**Rancho Las Virgenes
Regional Facilities Expansion IV**

Solids Handling and Composting Facilities

LAS VIRGENES MWD / TRIUNFO CSD
RANCHO LAS VIRGENES - REGIONAL FACILITIES EXPANSION IV
SOLIDS HANDLING AND COMPOSTING FACILITIES

ANAEROBIC DIGESTERS AND
 DIGESTER PUMP STATION

SHEET IS-8 OF 508 SHEETS

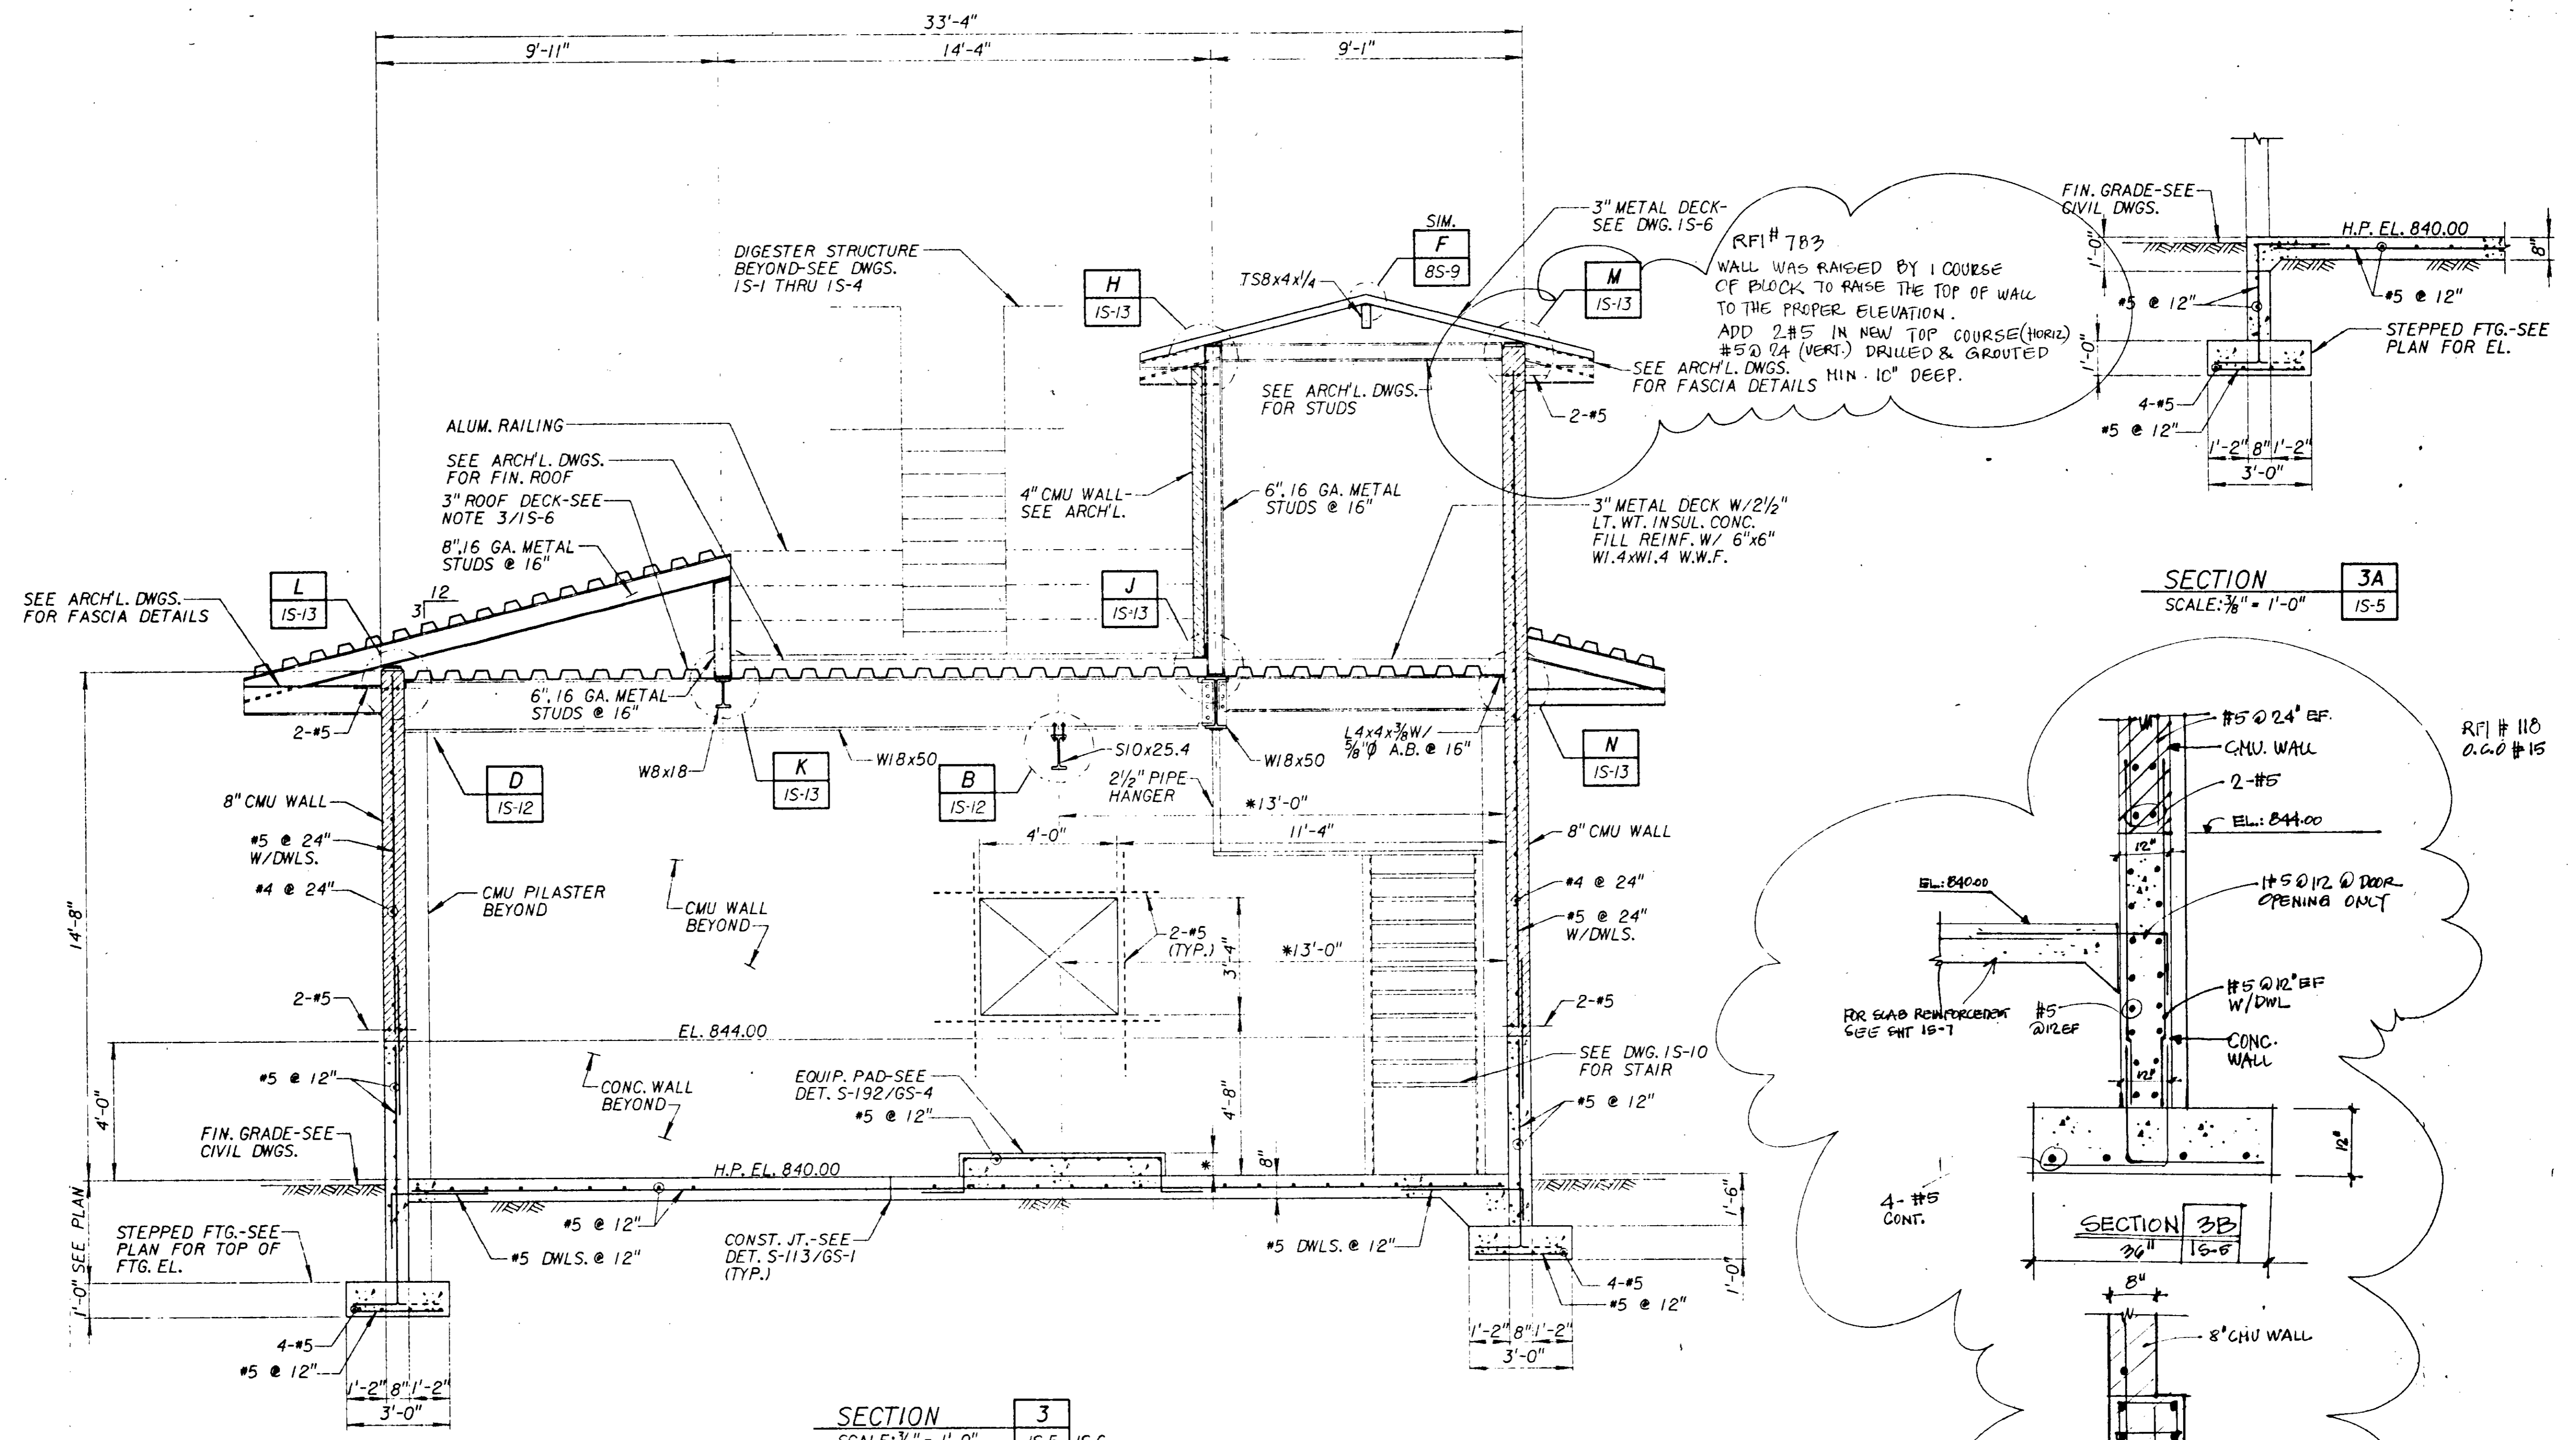
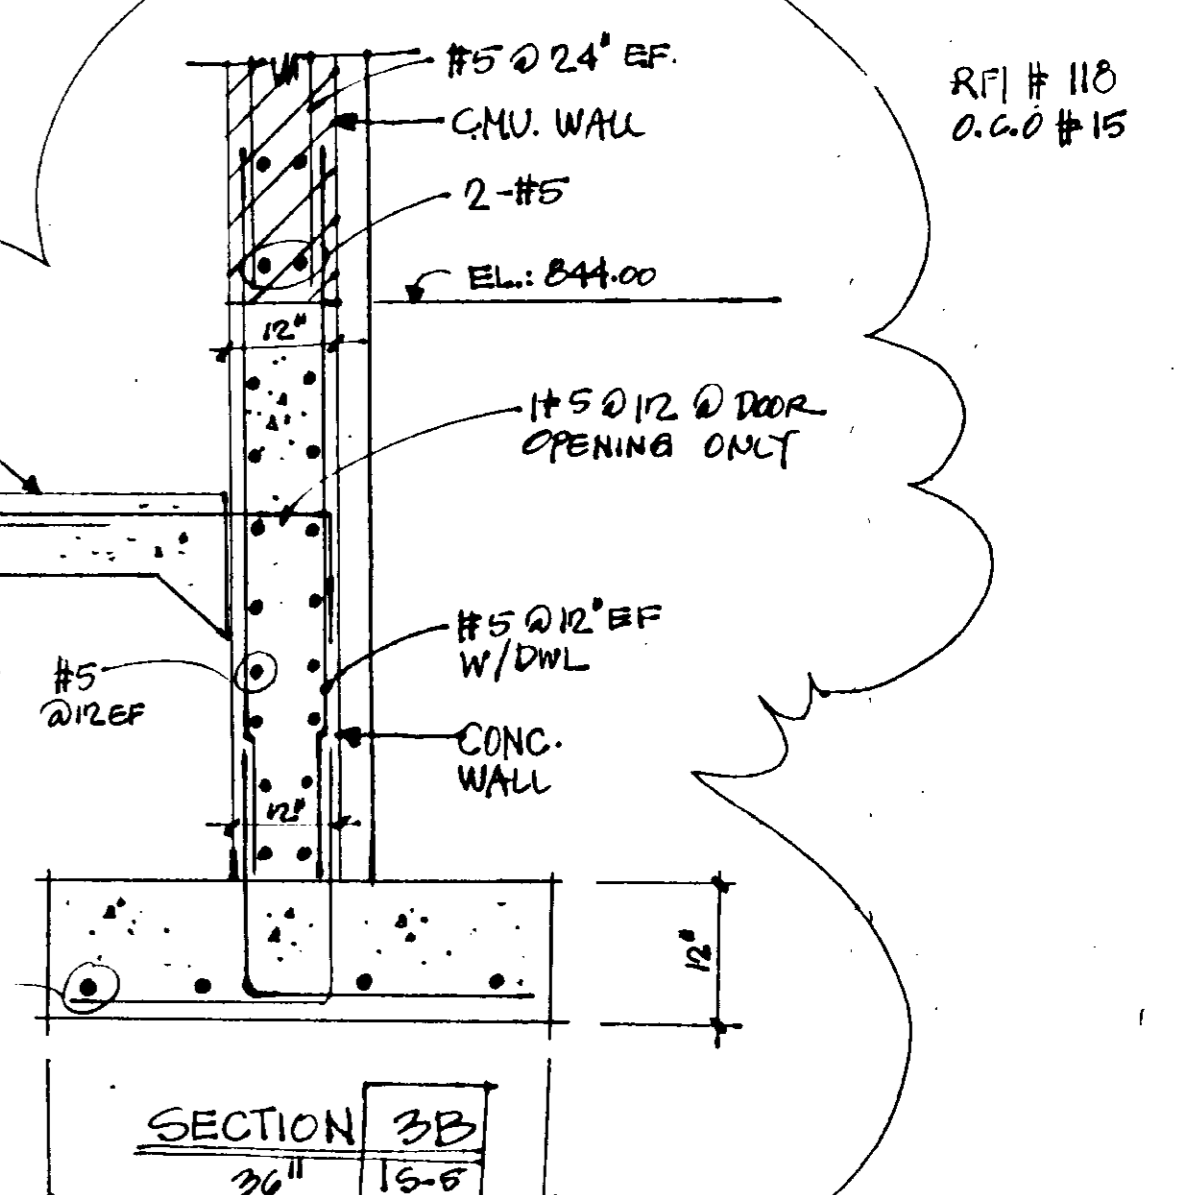
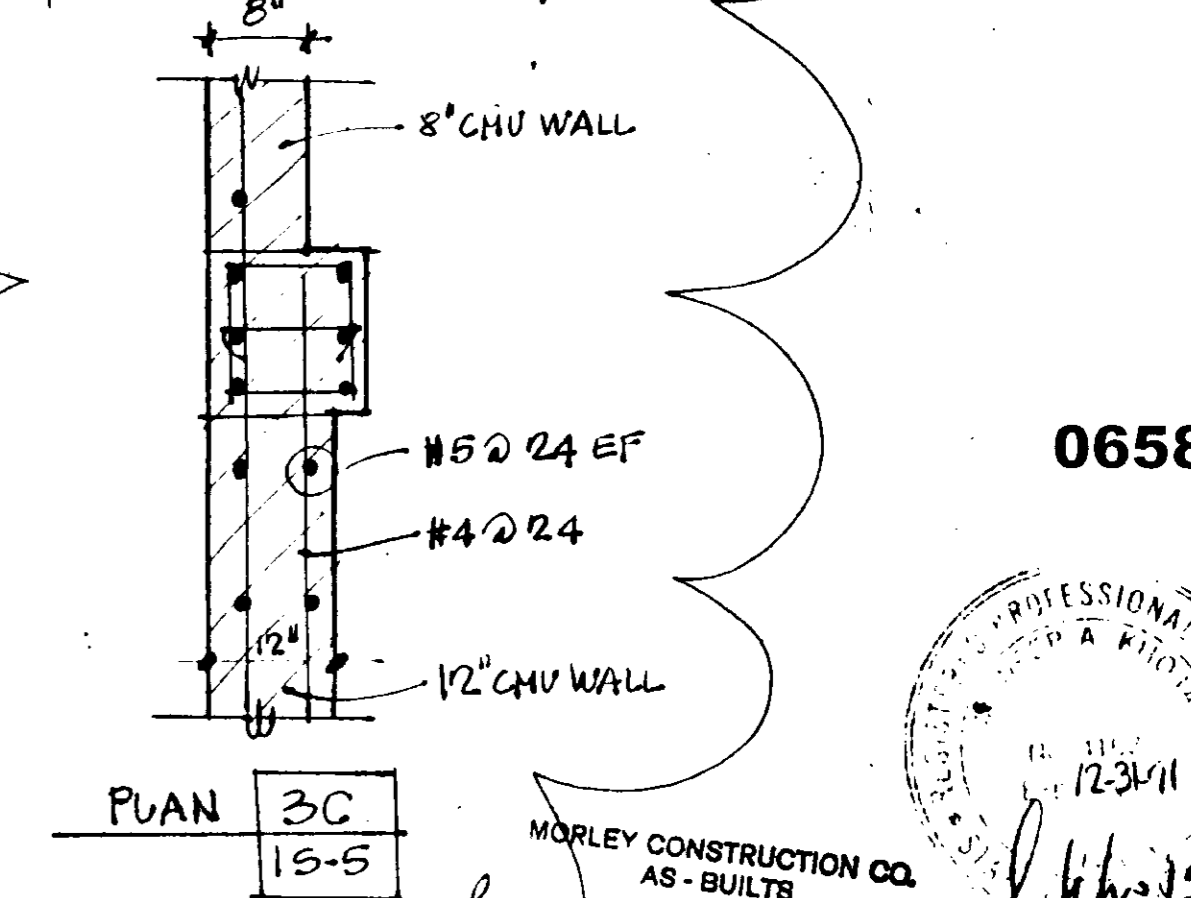
RFI # 783
 WALL WAS RAISED BY 1 COURSE OF BLOCK TO RAISE THE TOP OF WALL TO THE PROPER ELEVATION.
 ADD 2 #5 IN NEW TOP COURSE (HORIZ) #5 @ 24" (VERT.) DRILLED & GROUTED FOR FASCIA DETAILS MIN. 10" DEEP.
